ATTACHMENT 4 TO TXX-15101
EMERGENCY ACTION LEVEL
TECHNICAL BASES
(REDLINE AND STRIKEOUT VERSION)
(276 PAGES)

**Comanche Peak Nuclear Power Plant
EPP-201
Emergency Action Level Technical Bases Document**

DRAFT D2 6/24/15

Figure 1: Containment Integrity or Bypass Examples

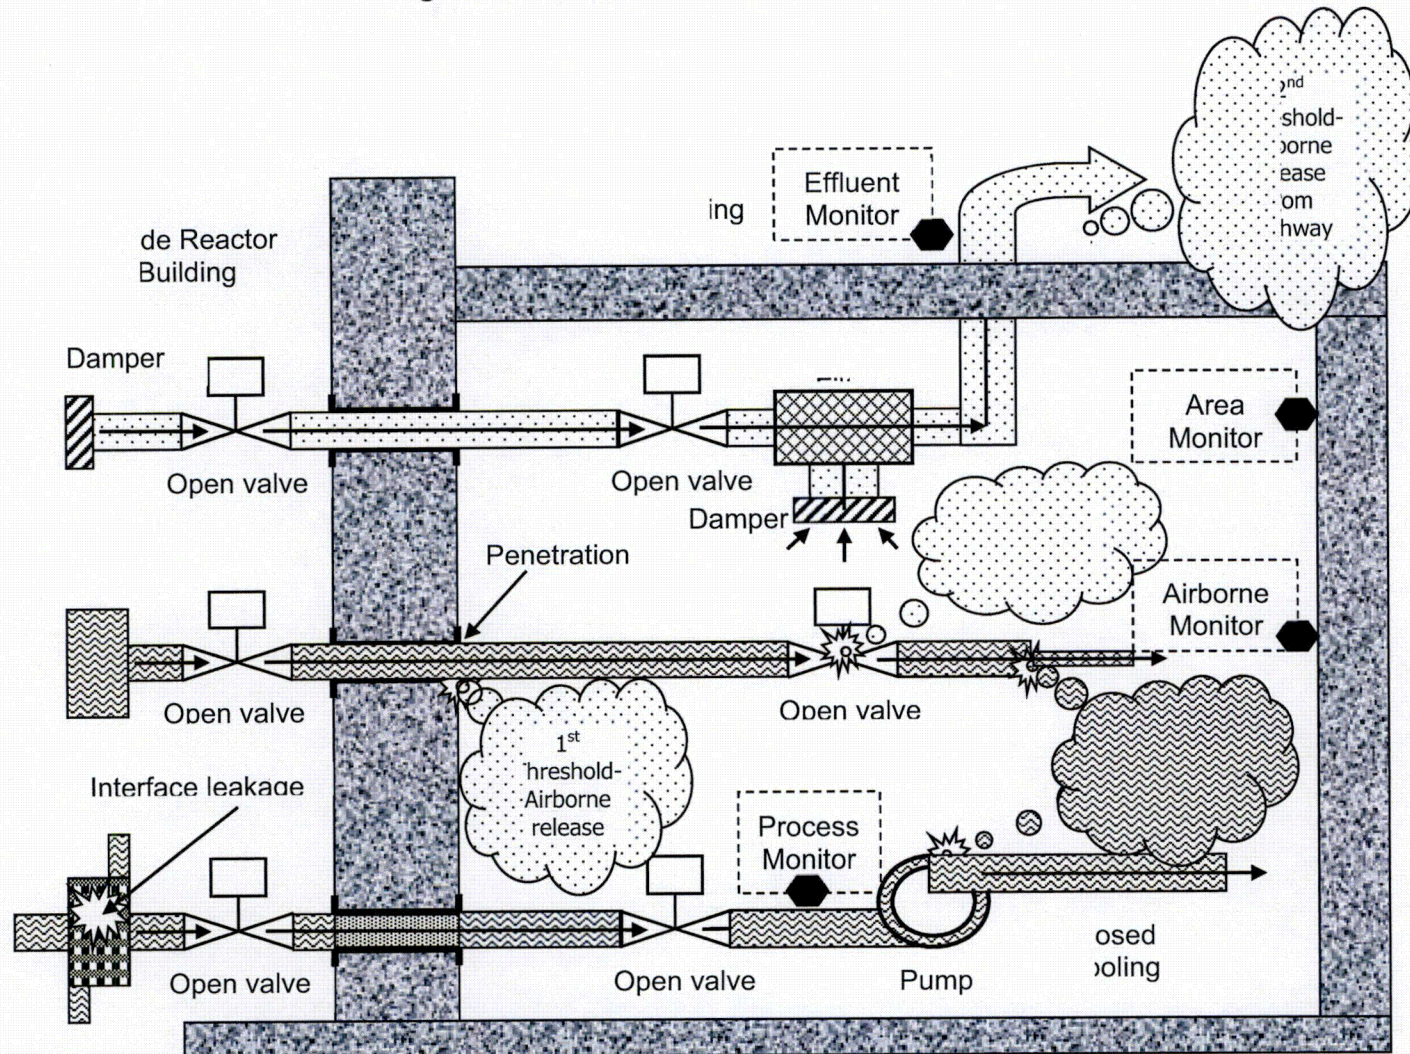
Refer to the top piping run of Figure 9-F-41. In this simplified example, the inboard and outboard isolation valves remained open after a containment isolation was required (i.e., containment isolation was not successful). There is now an UNISOLABLE pathway from the containment to the environment.

Refer to the bottom piping run of Figure 9-F-4~~1~~1. In this simplified example, leakage in an RCP seal cooler is allowing radioactive material to enter the Auxiliary Building. The radioactivity would be detected by the Process Monitor. If there is no leakage from the closed water cooling system to the Auxiliary Building, then no threshold has been met. If the pump developed a leak that allowed steam/water to enter the Auxiliary Building, then second threshold ~~4.B~~ would be met. Depending upon radiation monitor locations and sensitivities, this leakage could be detected by any of the four monitors depicted in the figure and cause the first threshold ~~4.A.1~~ to be met as well.

Refer to the middle piping run of Figure 9-F-41. In this simplified example, a leak has occurred at a reducer on a pipe carrying reactor coolant in the Auxiliary Building. Depending upon radiation monitor locations and sensitivities, the leakage could be detected by any of the four monitors depicted in the figure and cause threshold 4.AD.1 to be met as well.
